Moorebank Precinct West Stage 2 Proposal Response to Submissions

Appendix D: Noise & Vibration supplementary response material

Our Ref: 15324 Ltr 170317

Re: MPW Stage 2 - RtS Technical Memo

Figure 1 Noise Monitoring Locations

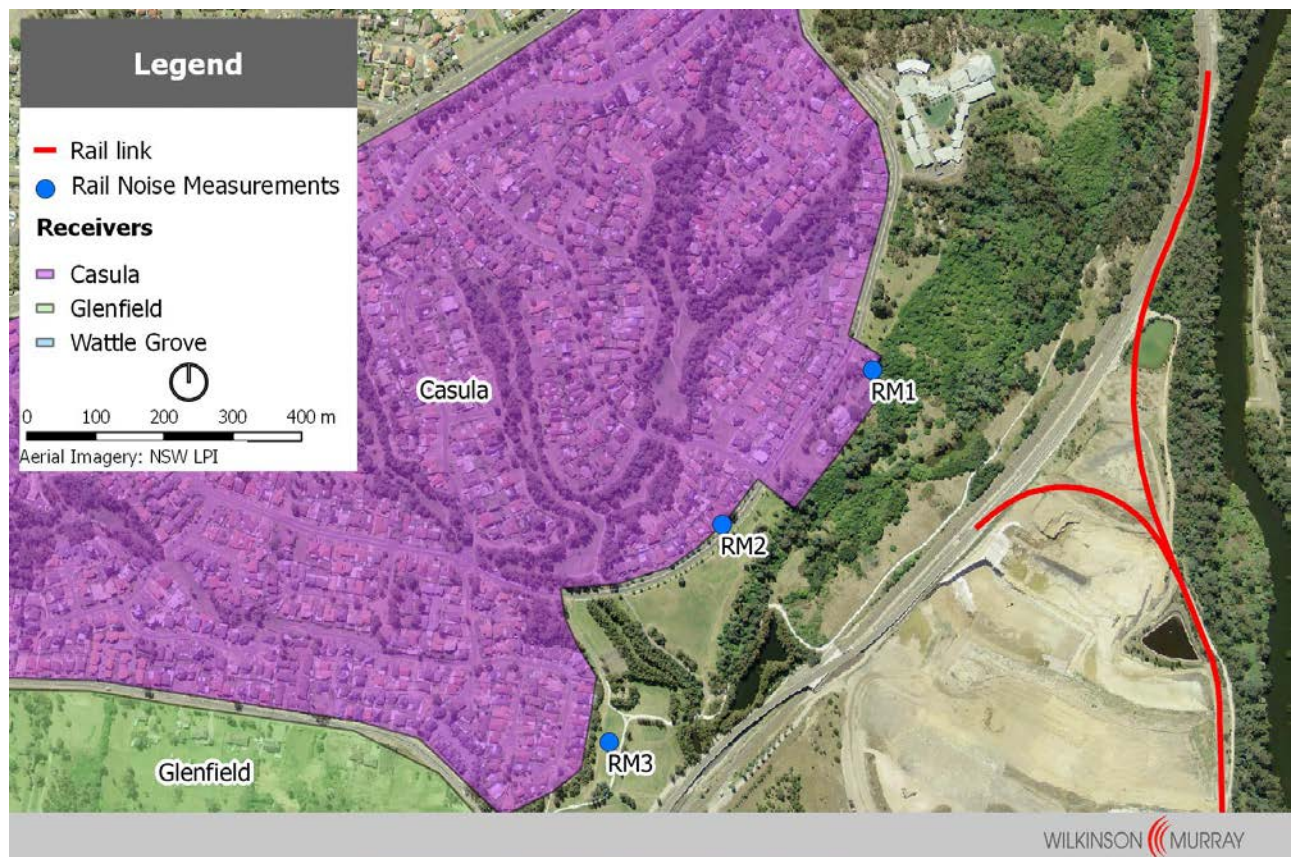
During the exhibition of the EIS, submissions were made regarding the assessment of rail noise from the Proposal by the NSW Environment Protection Authority (EPA). In particular, submissions requested more information relating to the quantification of existing levels of rail noise at the most potentially affected residential receivers, and further justification / demonstration that the Proposal would not noticeably increase rail noise at these location. An Excerpt from the submissiond received from the EPA on the Proposal, as they relate to rail noise have been provided in Table 1.

Agency	Submission
EPA	<p>The expected increase in rail noise due to the project should be quantified using rail noise levels measured or predicted at the same point as used to predict the rail noise level for the project, using the same parameter.</p>
	<p>The assessment used the LAeq(24hour) 48.4 dBA rail noise level predicted for year 2020 at 77 Leacocks Lane, Casula, in the Southern Sydney Freight Line Operational Noise and Vibration Management Plan (Appendix B of the Operational Environmental Management Plan), to suggest that the project's rail movements would increase LAeq(period) rail noise levels by less than 2 dB at Lot 21 Leacocks Lane, the closest receiver in the area.</p>
	<p>The assessment relied on some optimistic assumptions:</p> <ul style="list-style-type: none"> • The assessment stated that existing rail noise levels at Lot 21 Leacocks Lane were 3 to 5 dBA above those at 77 Leacocks Lane, because Lot 21 Leacocks Lane had direct line of sight to the Southern Sydney Freight Line and 77 Leacocks Lane does not. The 3 to 5 dBA appears to be a subjective estimate rather than being based on modelling. • Rail noise levels in the area will not change significantly between now and 2020. • The LAeq (24hour) predicted in the Southern Sydney Freight Line plan is equivalent to the LAeq (night) predicted in the assessment.

<p>The expected increase in rail noise due to the project should be quantified using rail noise levels measured or predicted at the same point as used to predict the rail noise level for the project, using the same parameter. The method used to estimate rail noise increase in the assessment was highly subjective and reliant on assumptions which were not adequately explained.</p>

Monitoring was undertaken at three locations, shown on Figure 1. The existing levels of rail noise will not be the same at all receivers in Casula, nor are the predicted rail noise levels from the Proposal. Therefore, the following monitoring locations were chosen to demonstrate the range of impacts at the most potentially affected receivers in Casula:

- RM1, which is representative of Glenfield Farm and adjacent residences along Leacocks Lane to the north of the intersection with Mackellar Street
- RM2, which is representative of residential receivers along Leacocks Lane to the south of the intersection with Mackellar Street
- RM3, which is representative of residential receivers on the eastern side of Slessor Road
